# Modification of Minister's Approval

## Section 75W of the *Environmental Planning and Assessment Act 1979*

**Project Approval 06\_02225  
Granted by the Minister for  
Planning on 3 June for the  
Hanson Concrete and Asphalt  
Facility, Eastern Creek**

**Figure 1: Key components of the modified Concept Plan**

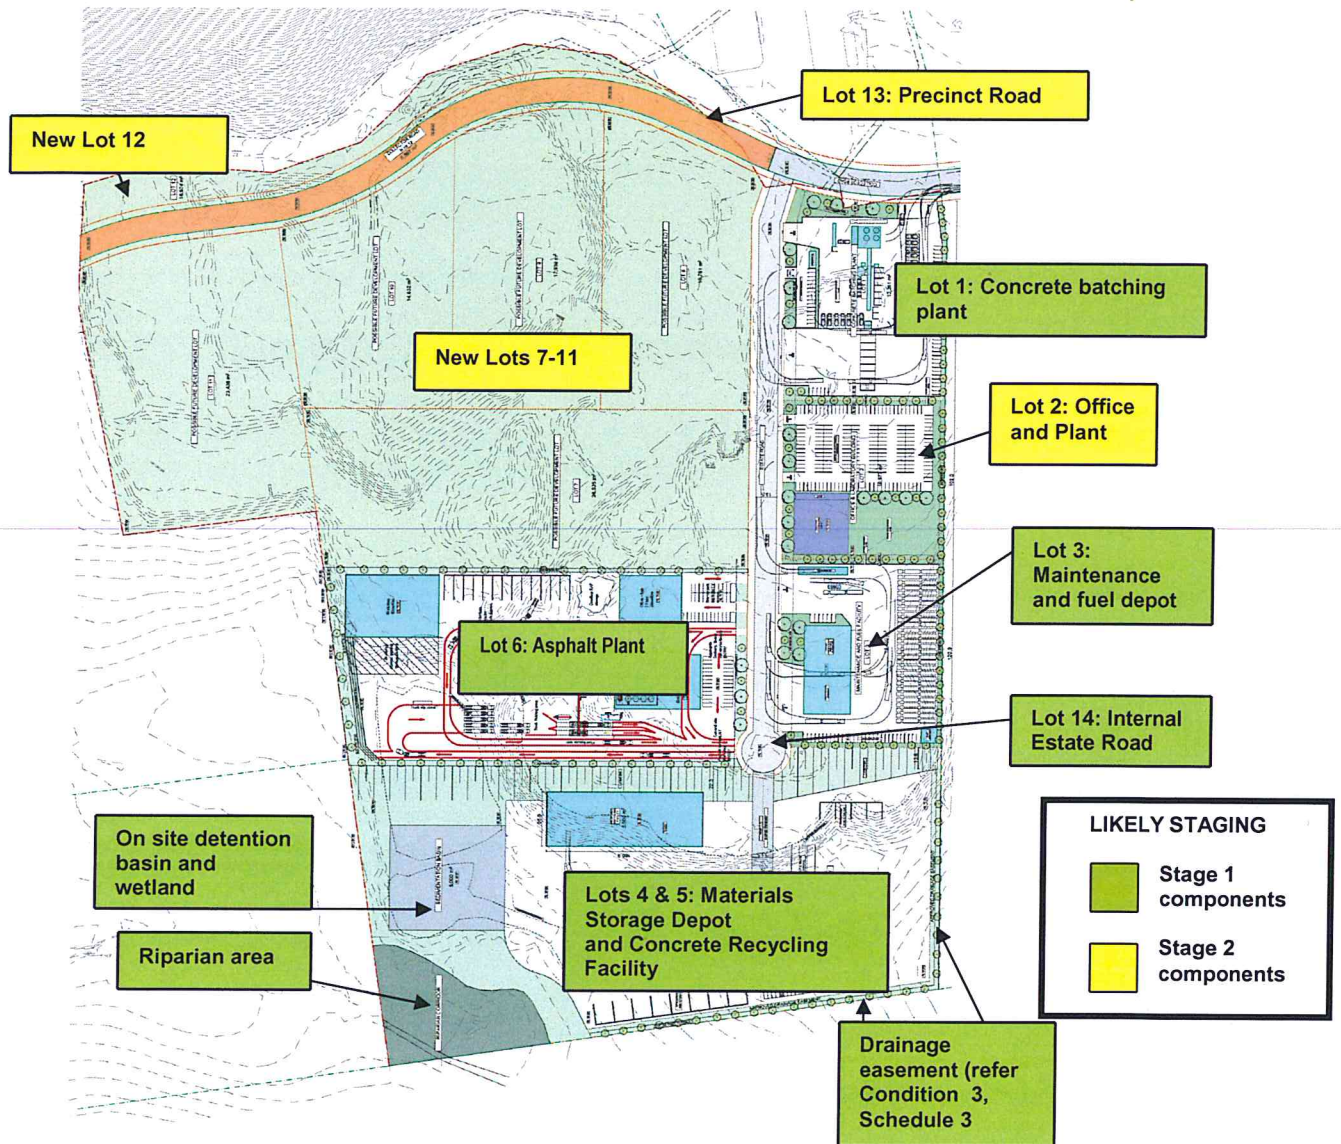
28. The Proponent shall not enter or disturb the riparian area shown in the figure in Appendix 1, except for the purpose of regeneration or restoration.
-

28. Replace Appendix 1 with new Appendix 1 as follows:

**Appendix 2: Subdivision Plan MOD 1**

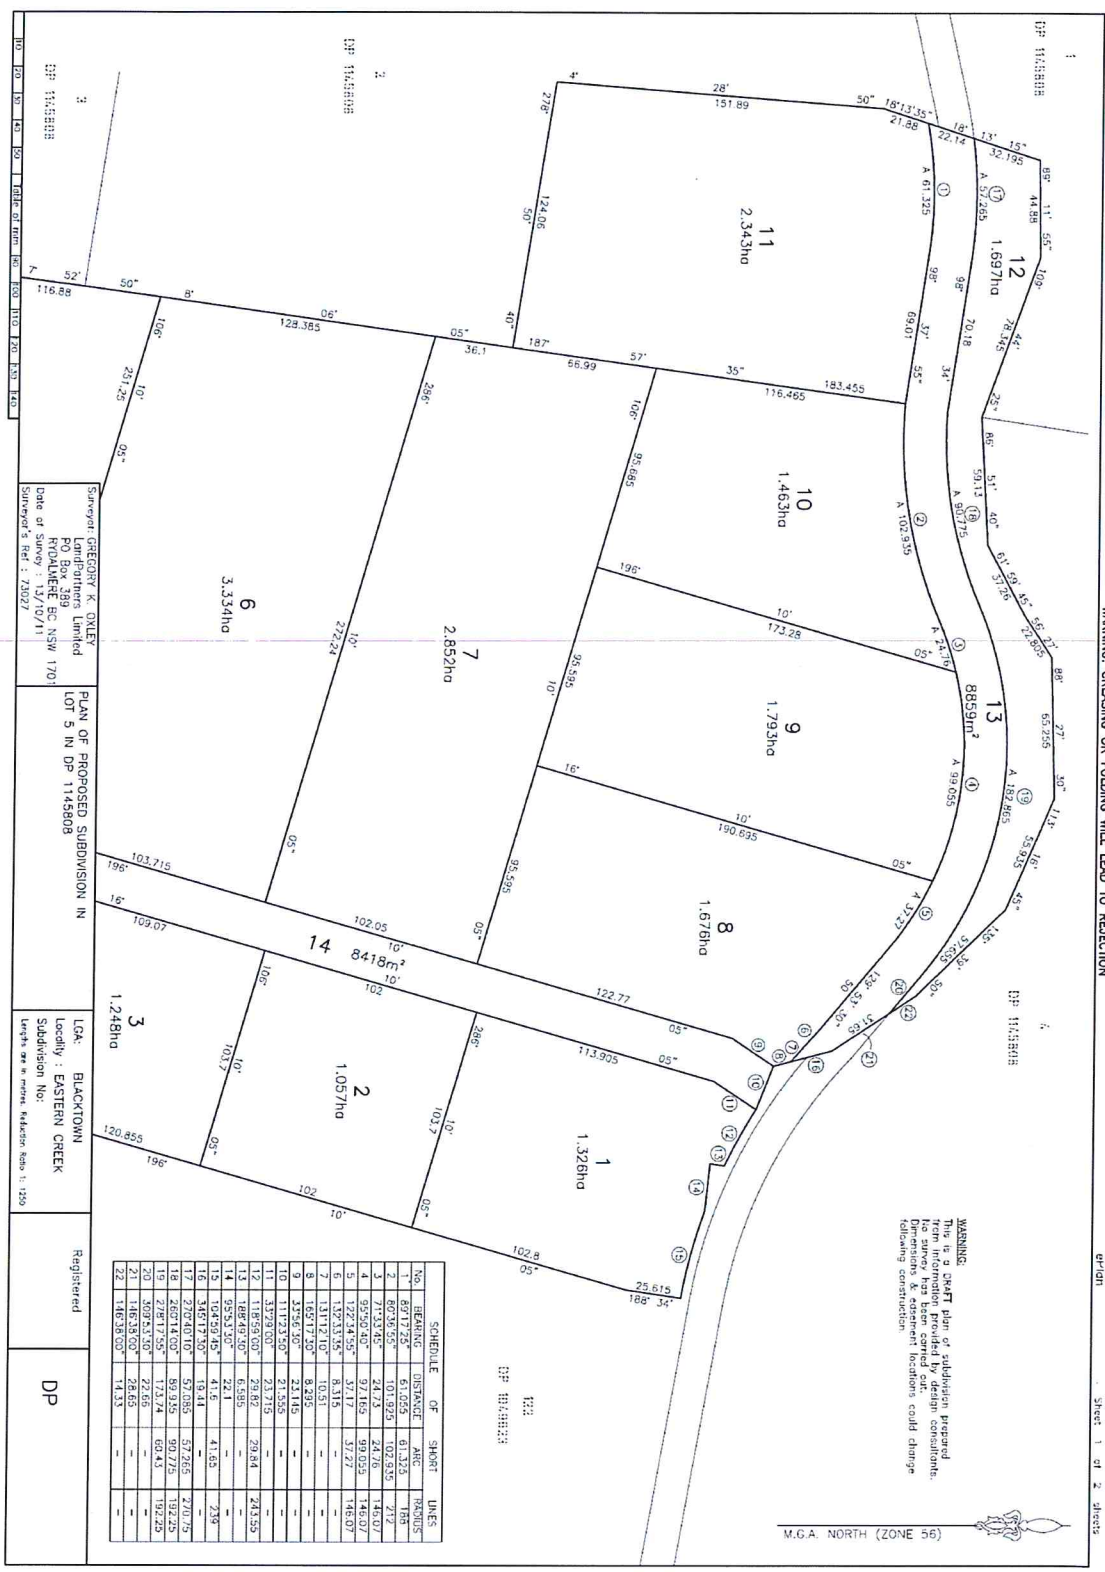
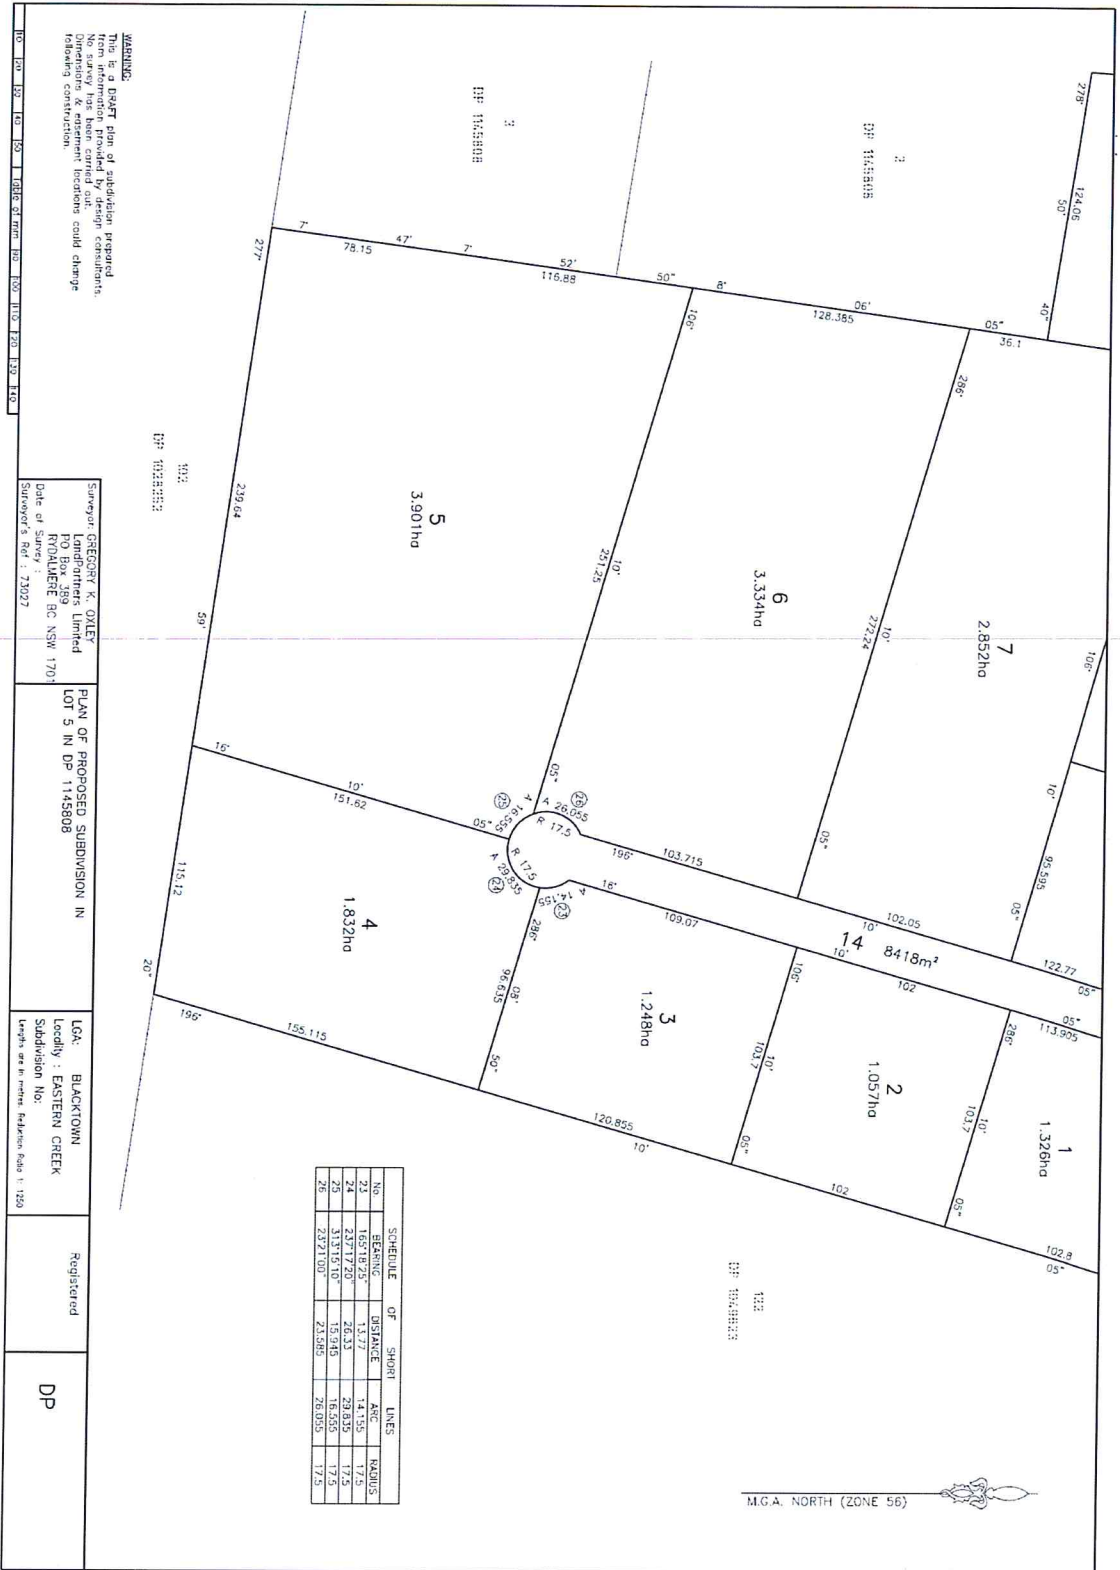
1. The Proponent shall carry out subdivision of the site in accordance with the Plan of Subdivision at Appendix 2, titled "*Plan of Proposed Subdivision in Lot 5 in DP 1145808*", dated 13 October 2011, prepared by Land Partners.

29. Replace Appendix 2 with new Appendix 2 as follows:

**Appendix 4: Proposed revegetation areas and existing riparian area to be revegetated, restored or maintained**

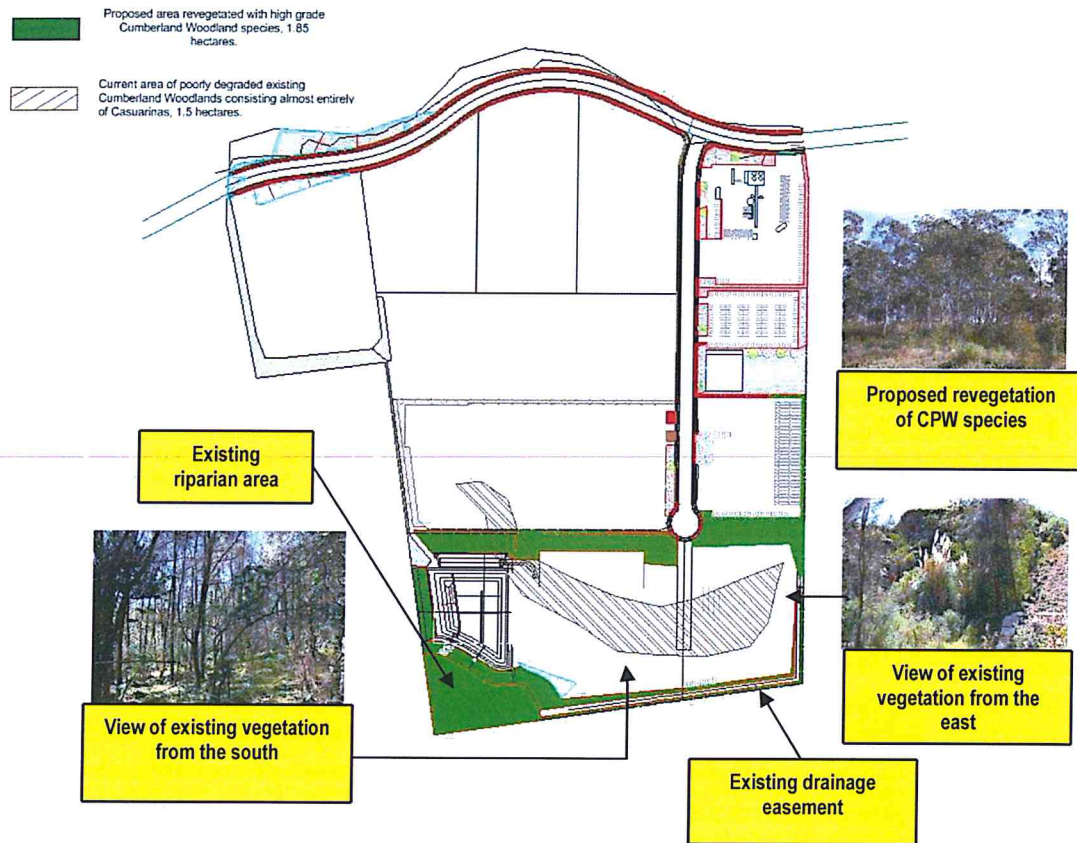
31. Insert new Appendix 4 after Appendix 3 as follows:
